Final Environmental Statement

related to the operation of
Limerick Generating Station,
Units 1 and 2

Docket Nos. 50-352 and 50-353

NUREG-0974

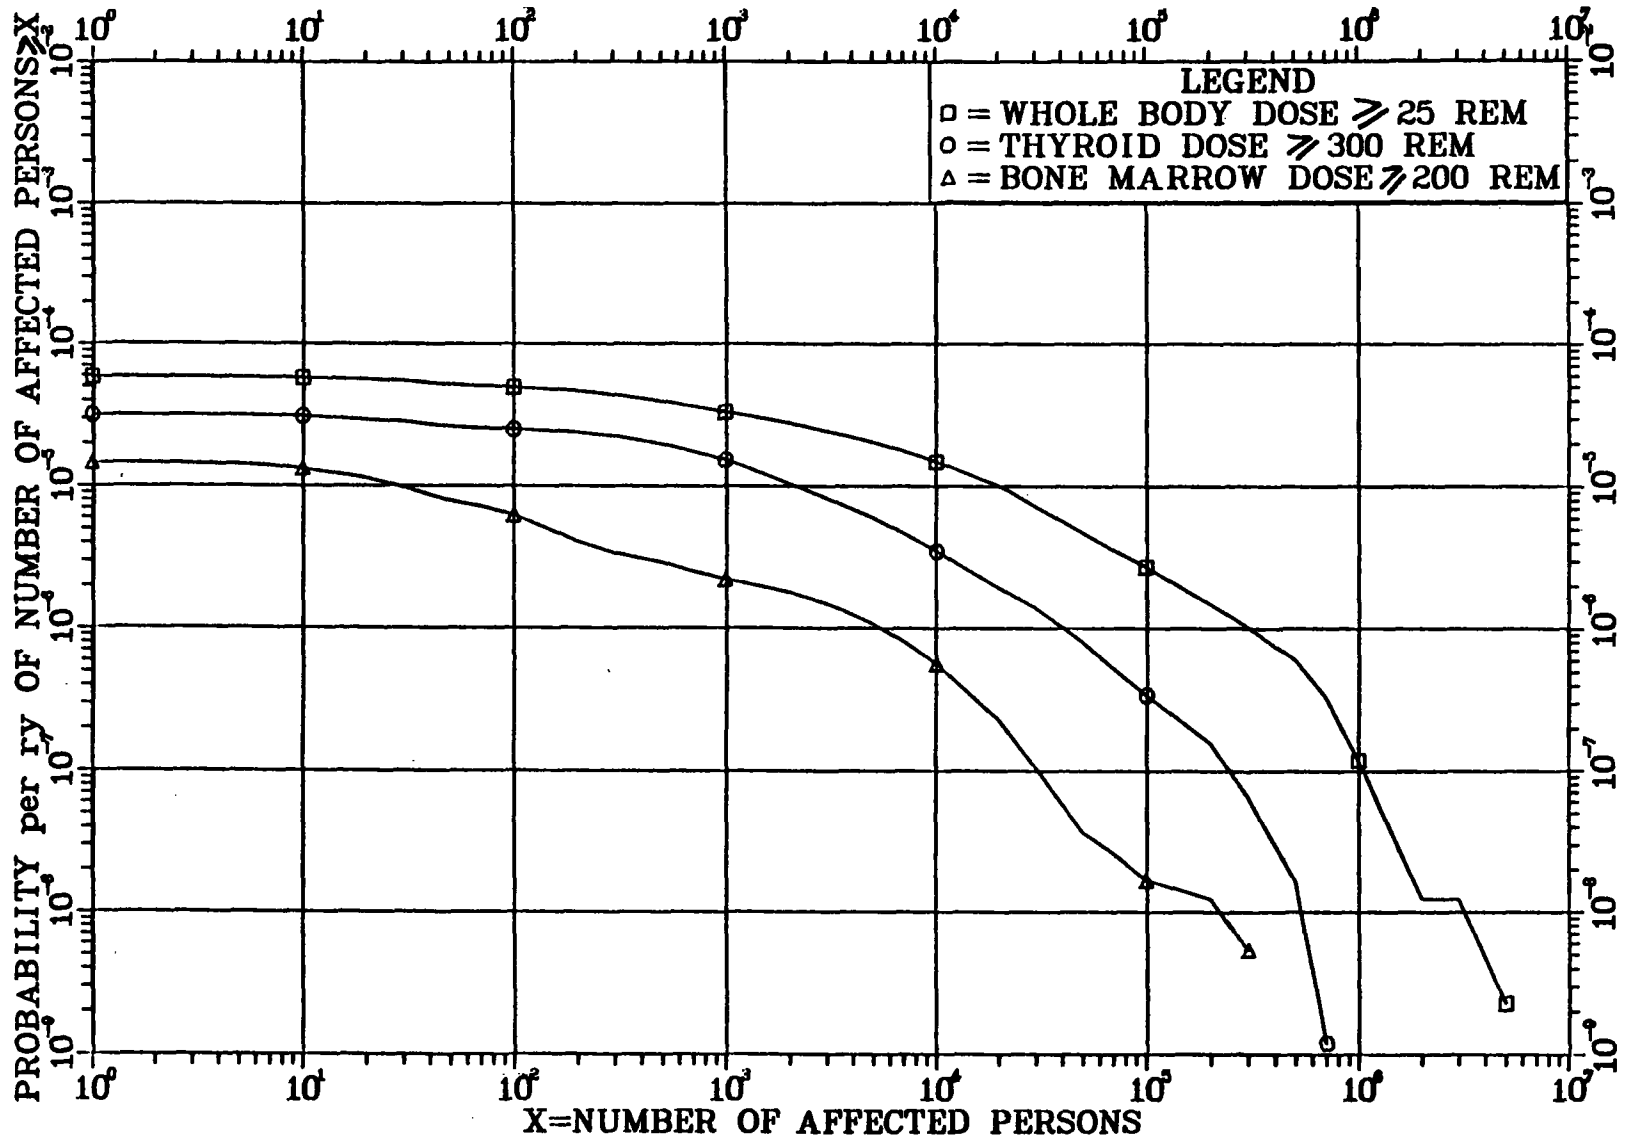
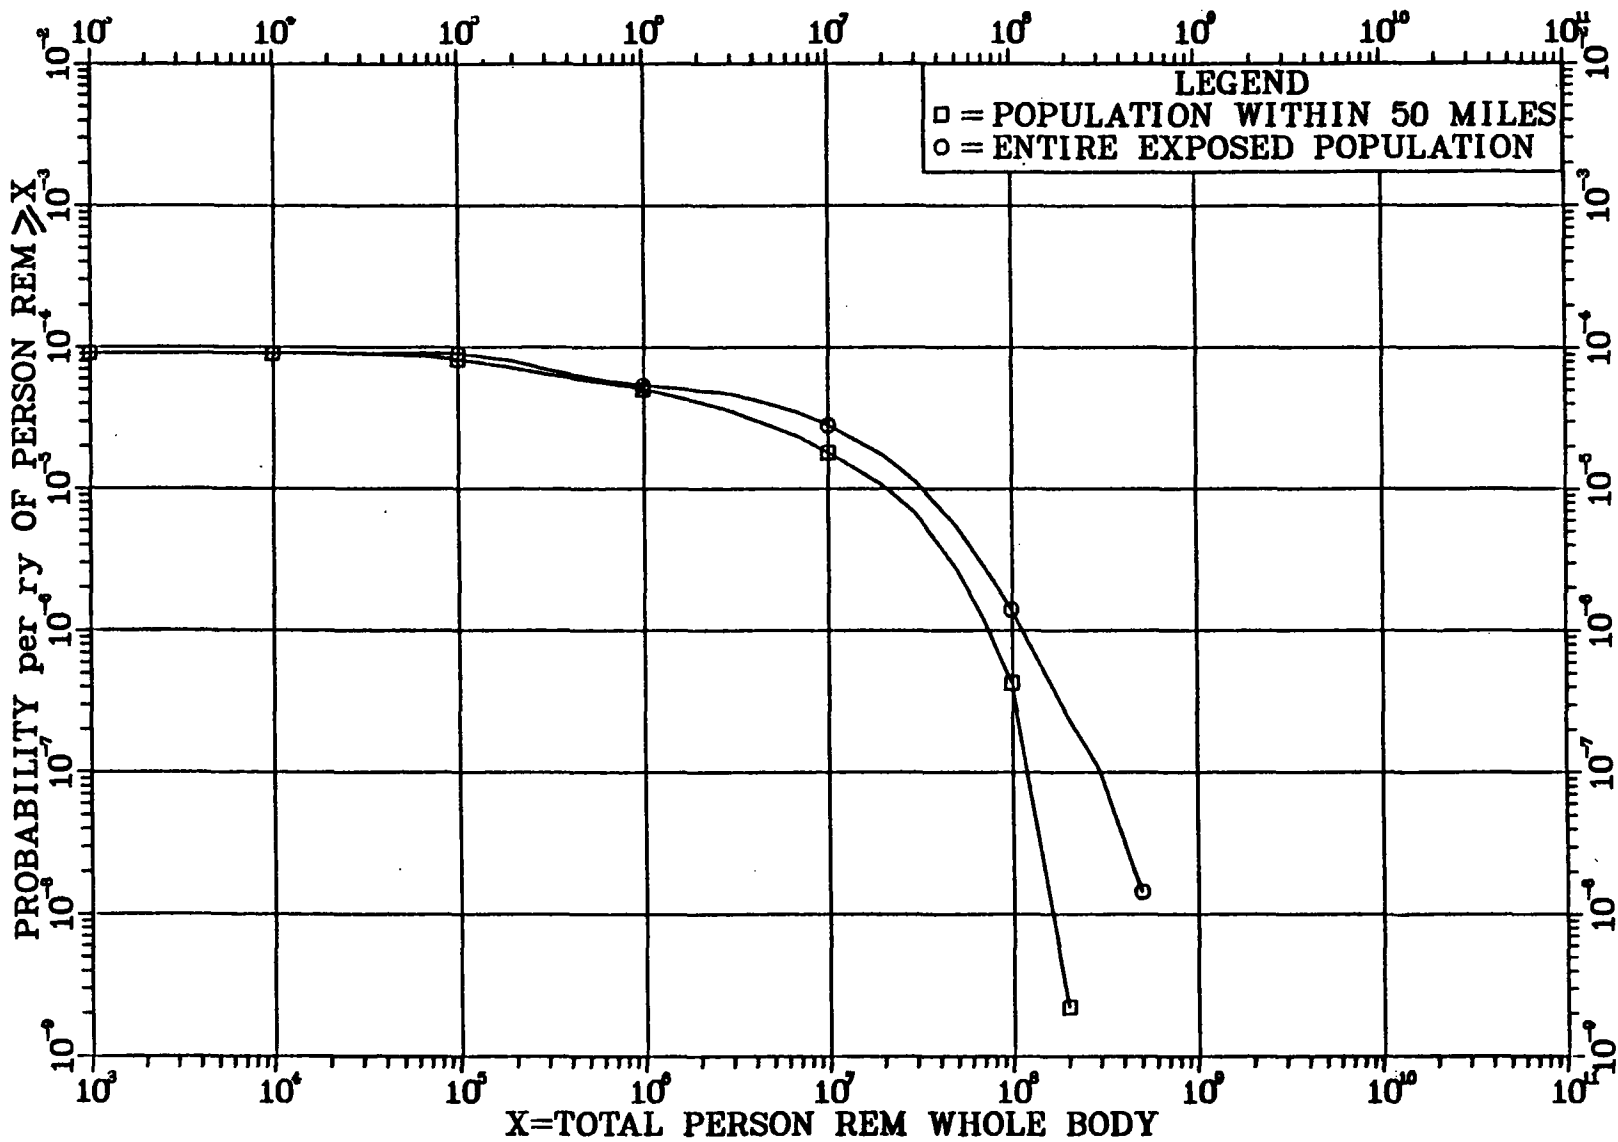
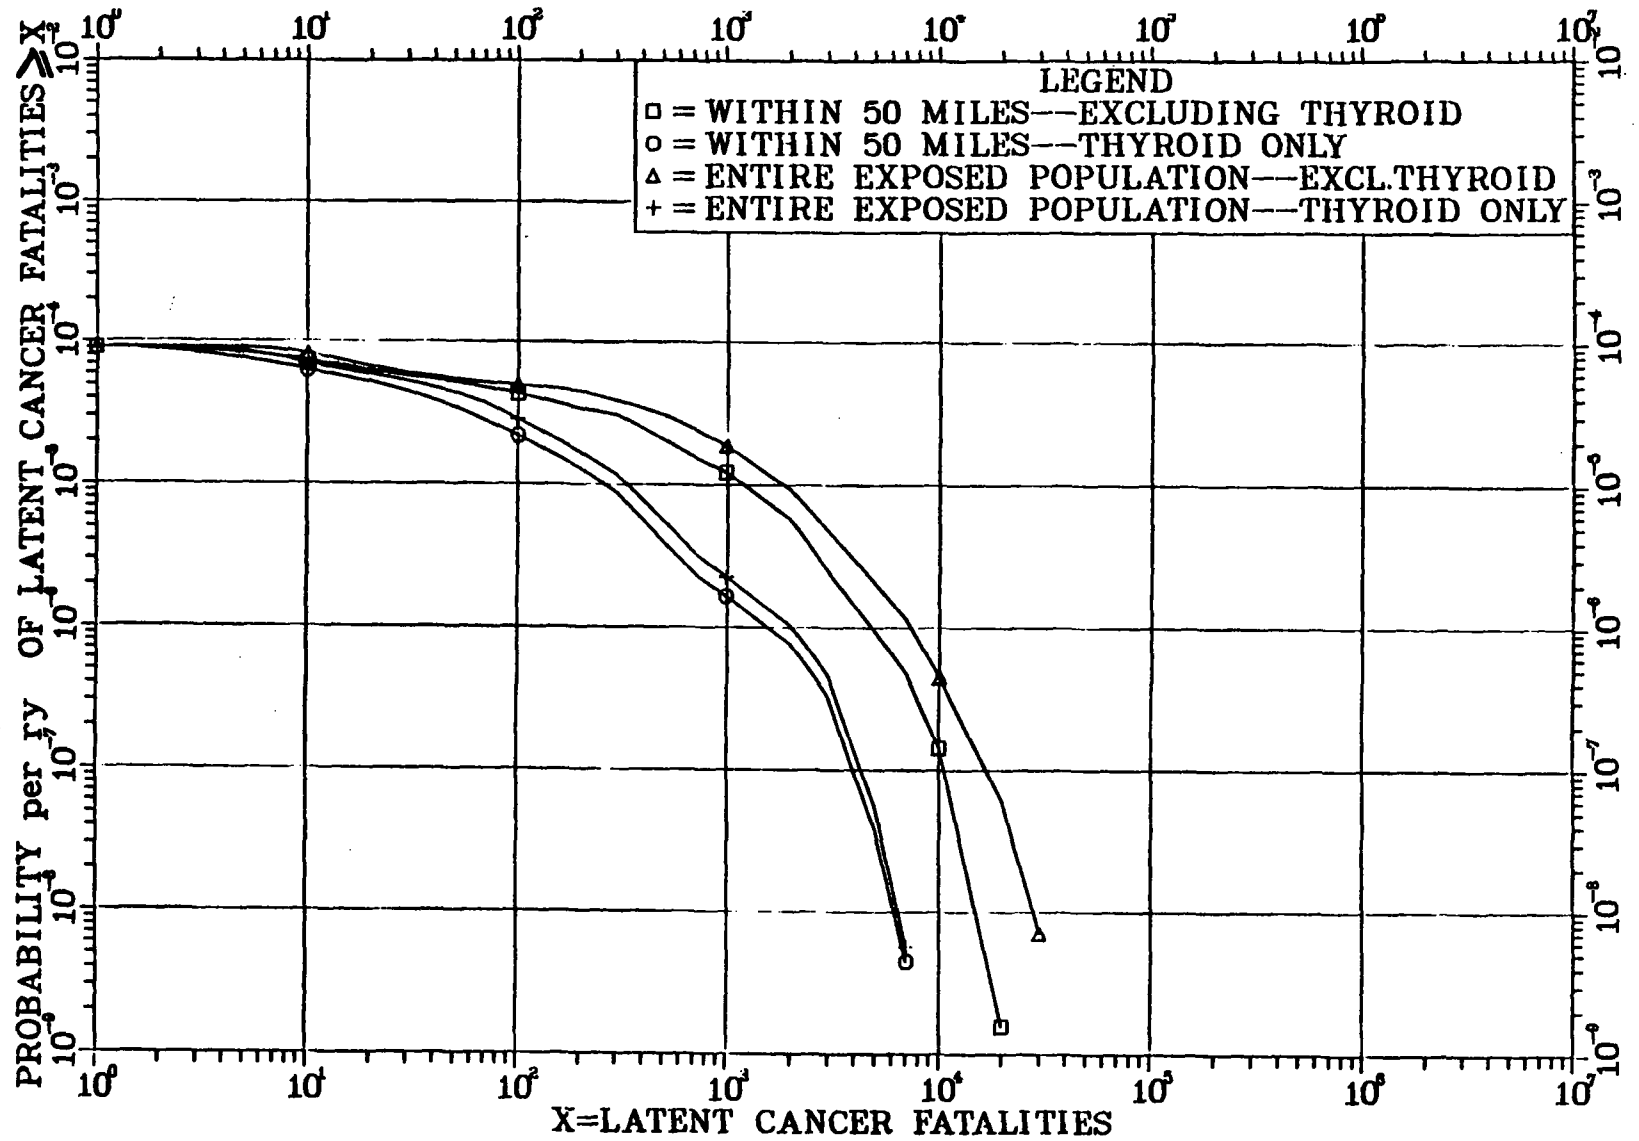
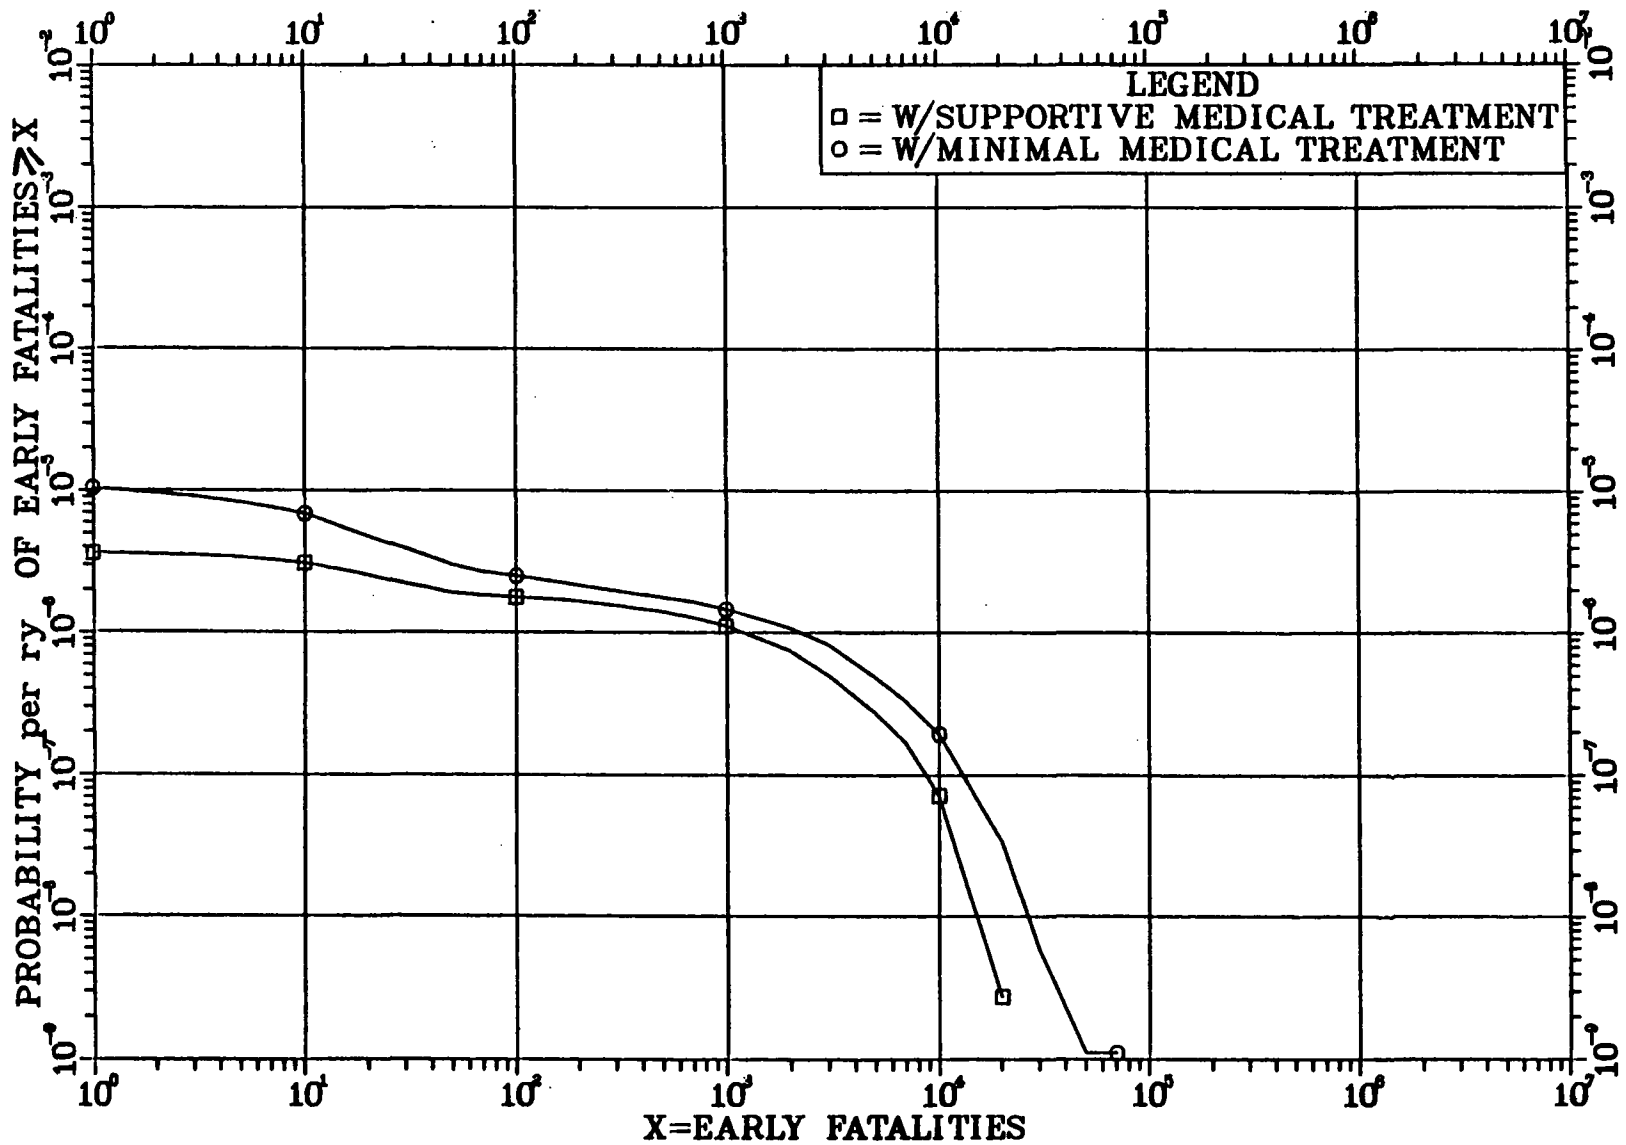
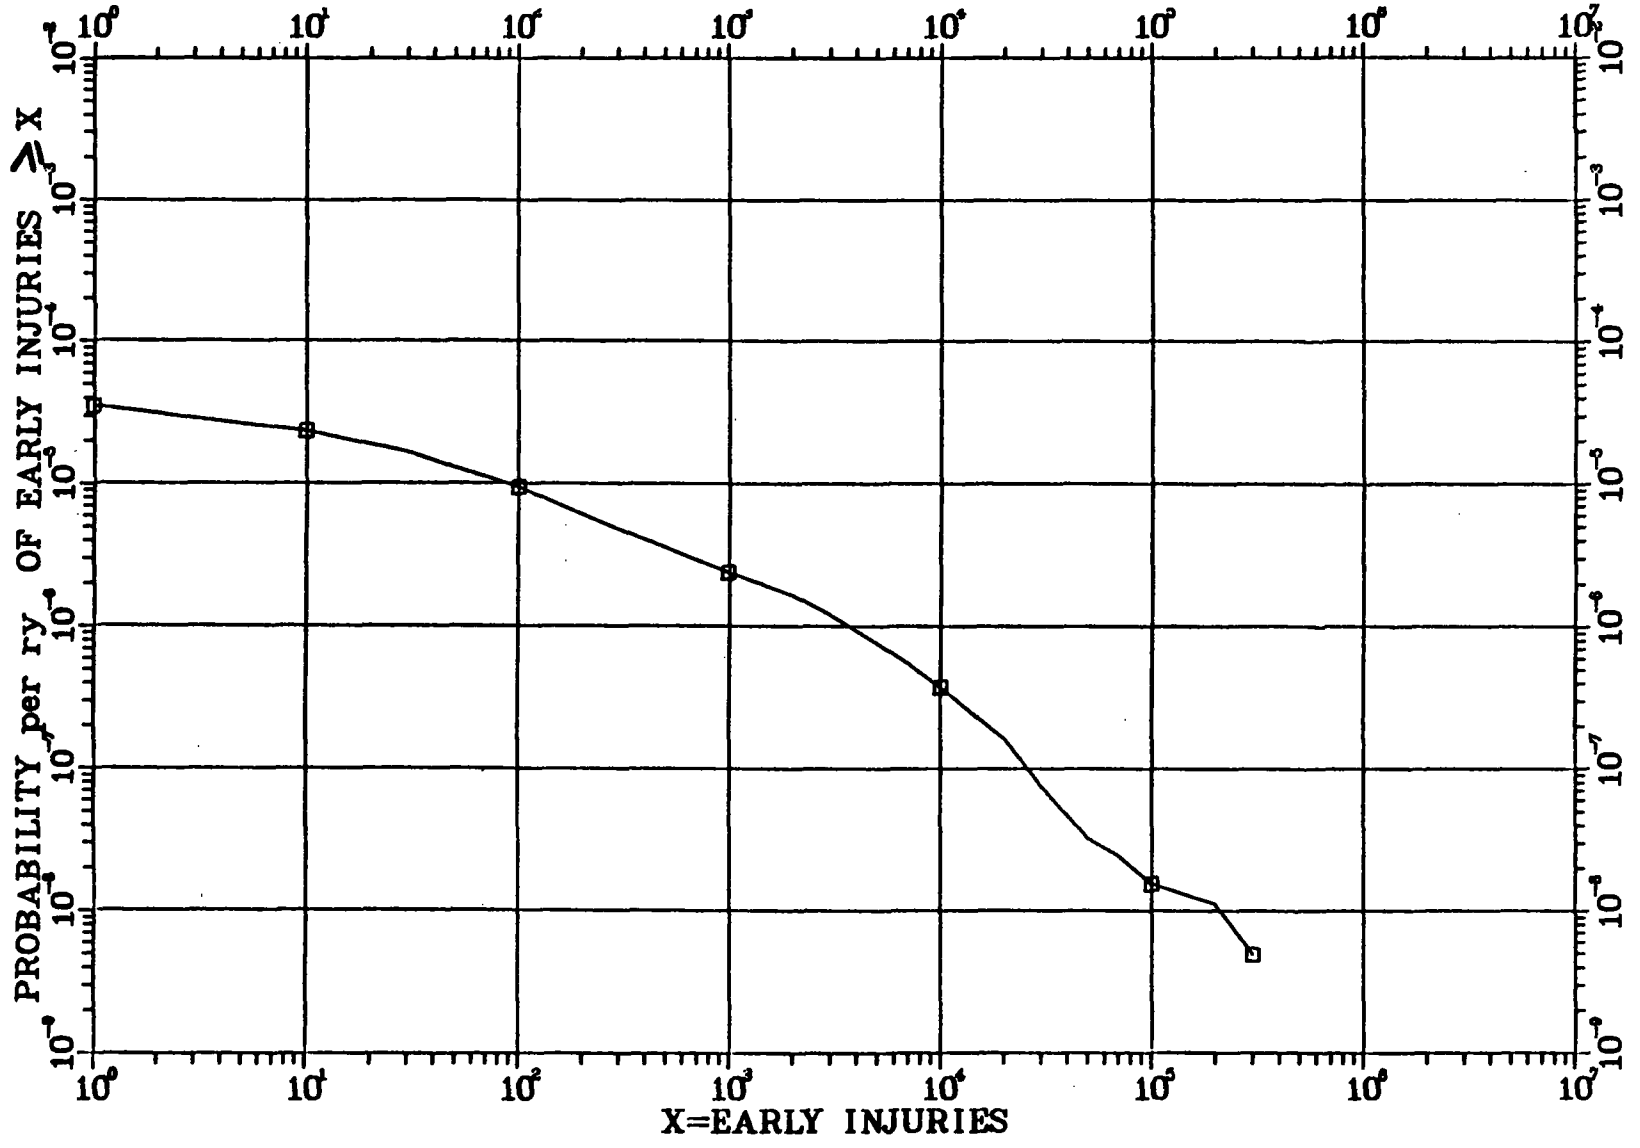
"The results shown are more severe than presented in the LGS SARA. This is due to the higher frequencies, higher release fractions, and more pessimistic emergency response. The major difference is in the CCDF for early fatalities (Figure 5.4e) which lies above the upper

Figures 5.4b to 5.4g and Table 5.11g: The results shown are more severe than presented in the LGS SARA. This is due to the higher frequencies, higher release fractions, and more pessimistic emergency response. The major difference is in the CCDF for early fatalities (Figure 5.4a) which lies above the upper 95% curve from SARA. The represented upper confidence levels (cross hatched areas) are not substantiated and are unprecedented for any assessment of risk. It is difficult to believe that these are plausible outcomes at any but the most extreme (much greater than 99%) confidence levels.
